Item #1:
Report Of The September 16, 2013 AC Meeting

MEMORANDUM

TO: Village President and Village Board
FROM: James M. Hogue, Village Planner
DATE: September 18, 2013
RE: Board & Commissions Report for 9/24/13

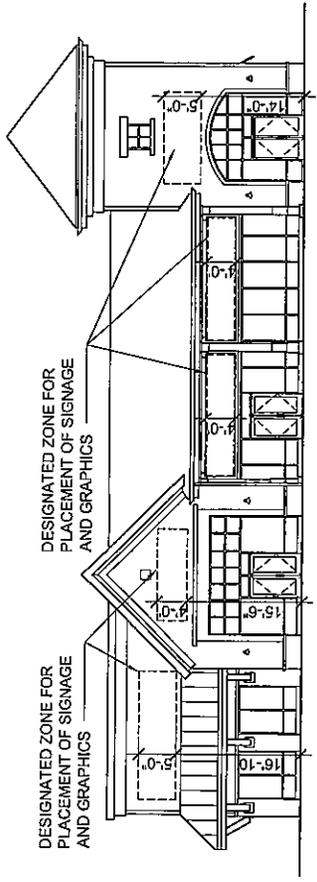
The AC had a concern with this sign as it related to the position on the building noting that the signage looked “tight” on this facade.

Commissioner Howard asked if the overall the sign could be reduced by 5 or 10% to address this issue.

The petitioner was concerned with visibility as this sign would be the only signage available to for the space. As such, the sign needs to be visible from Rt. 83 as well. The sign could likely be reduced (proportionally) by 5% and still remain functional however.

A motion was made by Commissioner Tapas, seconded by Commissioner Styer, to accept the sign as presented subject to the following conditions;

- The height and width of the sign be reduced proportionally by 5%
- The lettering & logo on the sign be moved closer together to allow the sign to be better centered on the building façade.
- Revisions shall be subject to staff review and approval.

RETAIL 'C' NORTH ELEVATION
SCALE: 1/16"=1'-0"

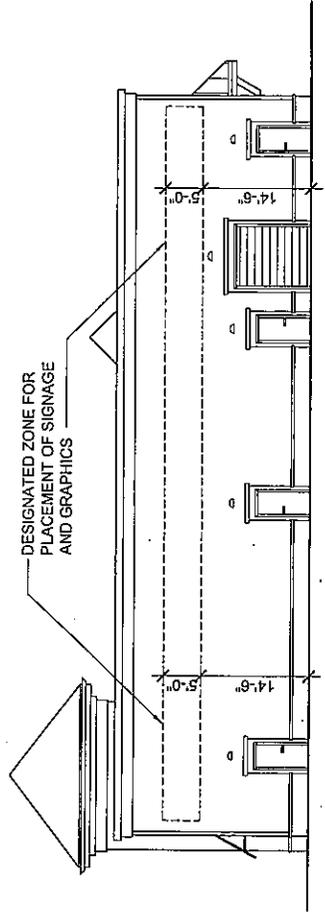
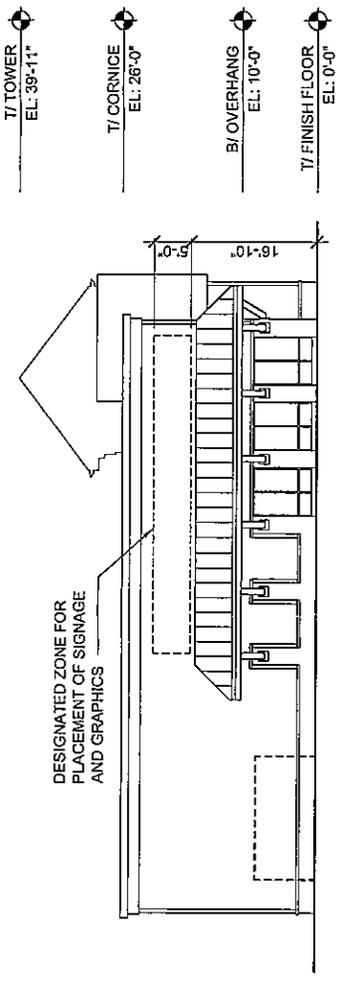
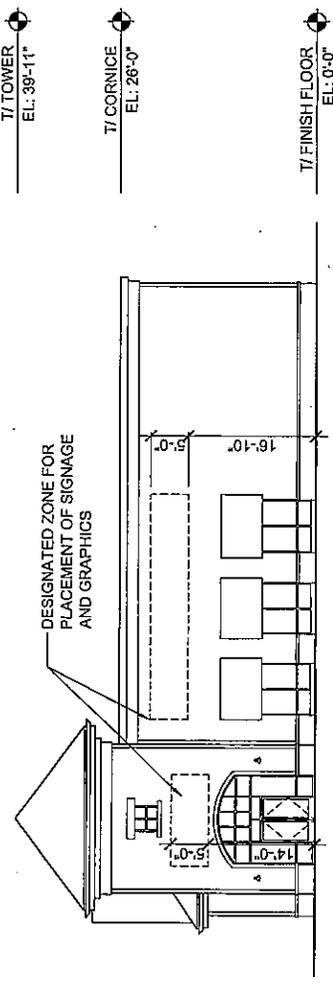
He then reviewed the proposed elevations for this structure noting “Building C” is largely a copy of “Building B” which is west of this structure and fronts on Route 83 (Caribou, Rosen Eye Care, The Barkery) .

“Building C” as proposed will measure 26 feet in height with a tower proposed to be approximately 40’ in height located on the west end of the structure. Both are within the height limitations of for structures within the development of 30 feet and 41 feet respectively. These building heights were established as part of the final PUD approval. A garage door is proposed on the south side of the structure to accommodate material delivery for a tenet. Aside for this difference the building elevations are identical to “Building B” as modified.

As proposed this building will measure 80' x 100' and contain 8000 square feet of floor area. The square footage proposed is consistent with the final PUD approval. The location of the proposed structure is within the building box as established on the final PUD site plan and is consistent with that plan. Materials proposed for this structure are identical to those used for "Building B". Landscaping will be installed in accordance with the approved final landscaping plan. 75 parking spaces will be provided for "Building C". This is consistent with the final PUD approval. The parking area is essentially installed save pavement stripping.

Individual tenant signage will be brought to the AC at a later date as requested. Signage will be handled with a "designated zone for placement" as was done with other structures within the development. Maximum signage size will be limited (70% of placement zone) as allowed by the PUD approval Ordinance. The designated placement zone is identified on the proposed elevations.

- A motion was made by Commissioner Styer, seconded by Commissioner Tapas, to accept the elevations for "Building C" dated September 6th 2013 as prepared by OKW Architects (project # 13010) and presented to the Architectural Commission on September 16th 2013. On a voice vote; all aye.
